UNITED STATES PATENT AND TRADEMARK OFFICE

APPLICATION NO.	FILING DATE	FIRST NAMED INVENTOR	ATTORNEY DOCKET NO.	CONFIRMATION NO.
10/050,539	01/18/2002	Sunao Ishizaki	NA04	7739
24998 7.	590 05/31/2002			
•	SHAPIRO MORIN & C	SHINSKY LLP	EXAMINER	
2101 L STREE WASHINGTO	T NW N, DC 20037-1526	-	NGUYEN, LAM S	
			ART UNIT	PAPER NUMBER
			2853	
			DATE MAILED: 05/31/2002

DETAILED ACTION

FIG. 2

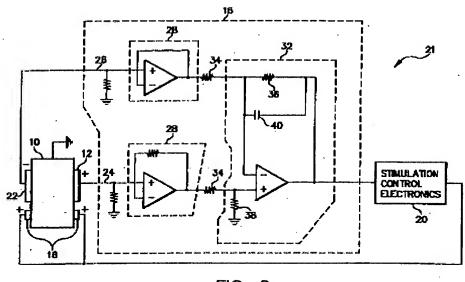
However, Katerberg et al. discloses that the feedback loop for feeding back the terminal voltage of said piezo-electric actuators includes a capacitor for leading to signal phase in high frequency range (FIG. 2, element 40).

Therefore, it would have been obvious for one having ordinary skill in the art at the time the invention was made to include such capacitor as designed by Katerberg et al. into the design of Mitsuhashi et at. because this capacitor prevents oscillation in order to gain the stability of the operation of the amplifier as taught by Katerberg et al. (column 3, line 55-60).

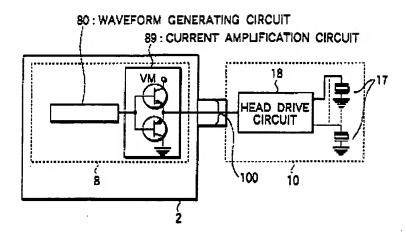
Isamoto discloses a drive circuit of an ink jet head of a serial type ink jet printer, which includes a carriage mounting nozzles (FIG. 7A) and pressure generating chambers and in which ink droplets are jetted from the nozzles by sharply changing volumes of said pressure generating chambers (FIG. 13A, element 234) filled with ink by applying drive waveform signal to piezoelectric actuators (FIG.13A, element 239) provided corresponding to said respective pressure generator chambers while moving said carriage reciprocally in a direction perpendicular to a feeding direction of a printing sheet (FIG. 1), comprising:

a control circuit board (FIG. 12, element 2) mounting a waveform generator (FIG. 1, element 80) for generating a signal for driving said ink jet head, a power amplifier (FIG. 12, element 89) for amplifying the output signal of said waveform generator, an image memory for storing printing data (FIG. 8, element 4-5), and a data transmitter for transmitting the image data stored in said image memory as a serial data thereon (FIG. 1, element 9);

an intermediate circuit board (FIG. 11A, element 18) mounted on said carriage and mounting a data receiver (FIG. 11A, element 13) for receiving the serial data from said data transmitter, transfer gates (FIG. 11A, element 160) for selecting piezo-electric actuators (FIG. 11A, element 17) on the basis of the received printing data and a level shifter (FIG. 11A, element 160) for matching voltage levels of said data receiver and said transfer gates thereon;

a cable for connecting said control circuit board and said intermediate circuit board each other (FIG. 12, element 100);
